Issue	**1**
Factory ID	**26326**
Date of Issue	**28-May-2026**

Eclipse Sports (Pvt.) Ltd.

Fire Safety Inspection Report

Pakistan Accord Initial Safety Inspection Report

Figure 1.4. Main building-Means of Egress

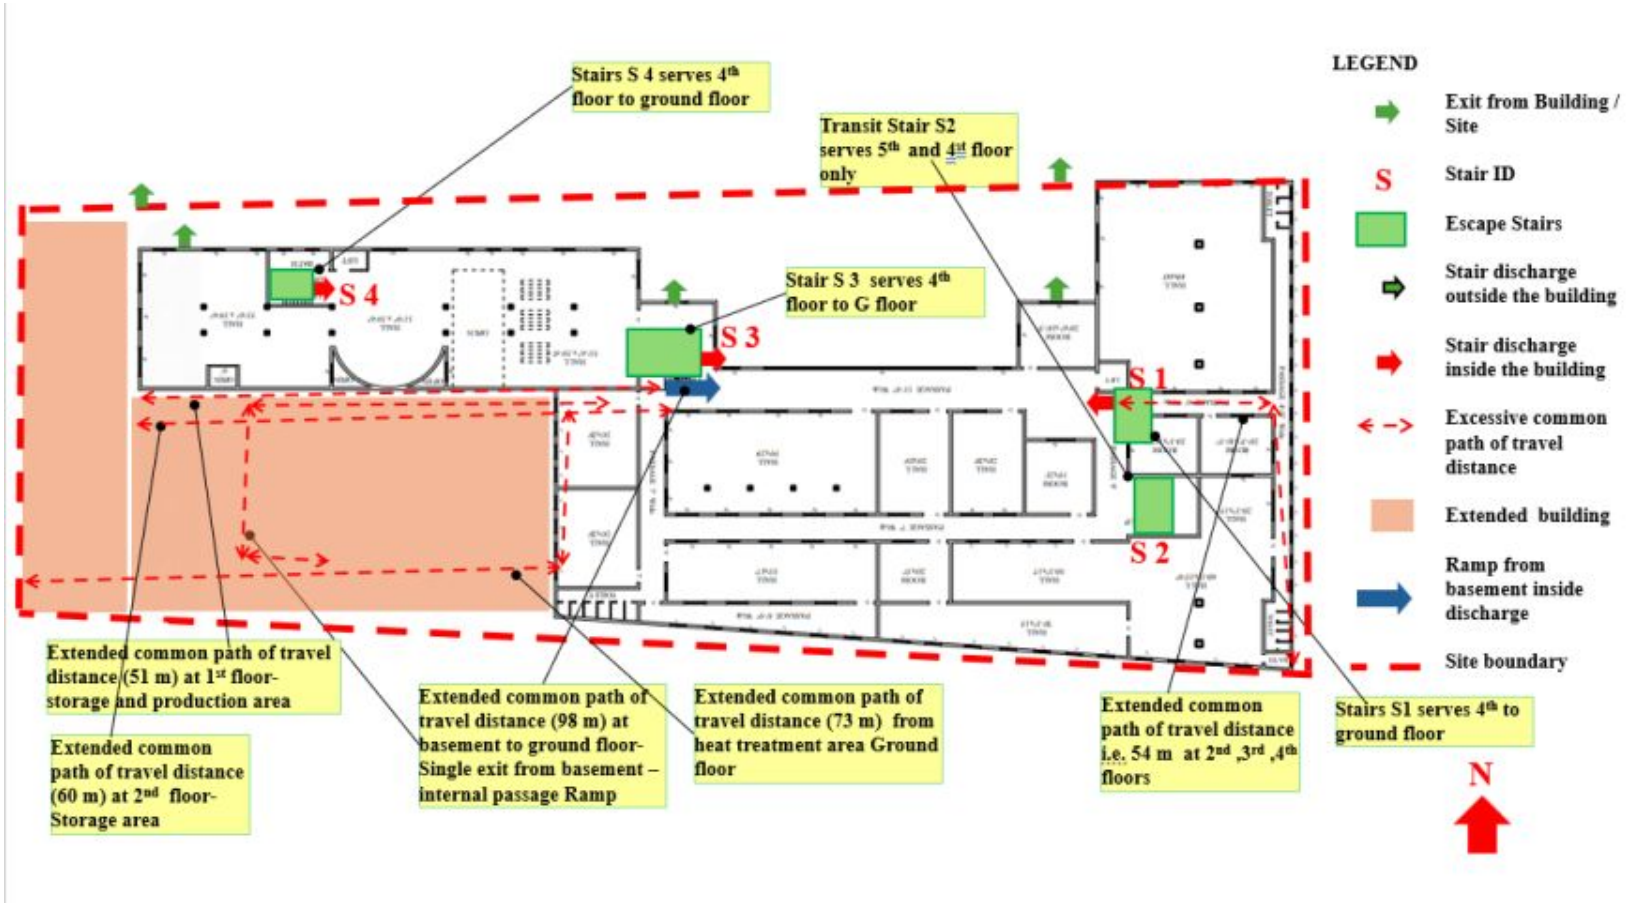
This is not always achieved, examples include (list not exhaustive):
- Common path of travel distances exceed permitted limits-Main building-Basement storage -98 m basement, Ground floor-73 m common path from heat treatment area,2nd floor -Storage-60 m, 3rd floor-Packing rear side -wash room area-54 m ,2nd floor ,1st floor, storage side near S-4-common path is 54 m,1st floor near to S-3 -Common path is 51m.

This is not always achieved, examples include (list not exhaustive):
- Single exit from some of the occupied floors- Main building -basement and 5th floor.

Timeline	Remediation Plan
Immediate CAP-0075412	Reduce the common path of travel distance to a maximum of 46 m in the areas with higher common path of travel or vacate the area until the travel distance is reduced.
Medium Term CAP-0075413	Propose a plan for addressing the excessive travel distance through alternative escape routes and/or additional exits and submit to Pakistan Accord for review prior to commencing any rectification works on site. Review travel distances from all areas in the building(s) to ensure that they meet the limits in the Pakistan Accord Standard.
Longer Term CAP-0075414	Implement the plan previous reviewed by Pakistan Accord and ensure all travel distances to emergency exits meet the requirements of the Pakistan Accord Standard.

Timeline	Remediation Plan
Medium Term CAP-0075352	Review each floor and area to ensure that the number of exits complies with Pakistan Accord Standard. Develop plans and drawings to provide additional exits where necessary. Submit the plan and drawings to Pakistan Accord for review and approval prior to commencing rectification works.
Longer Term CAP-0075353	Implement the above plan as agreed with Pakistan Accord. Number of exits from all floors and parts of the building should comply with Pakistan Accord Standard.
